SPECTRO3-Scope: Changes due to software update from SPECTRO3-Scope V4.2 to 4.3

This manual summarises the changes that were made with the software update from **SPECTRO3 V4.2** to **V4.3**.

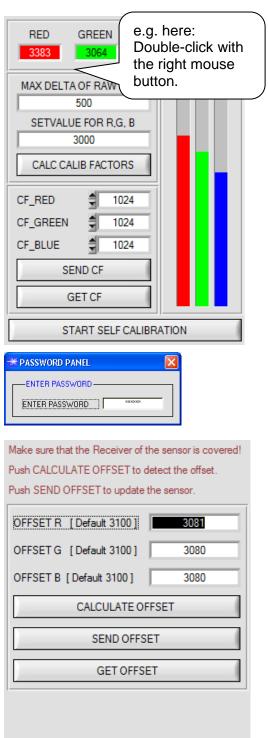
The full firmware version number is displayed after approx. 2 seconds when you move the mouse pointer on the status line.

COMMUNICATION PORT	3	SPECTRO3 V4.3 18/Mar/2014	
		SPECTRO3 V4.3.0	18/Mar/2014
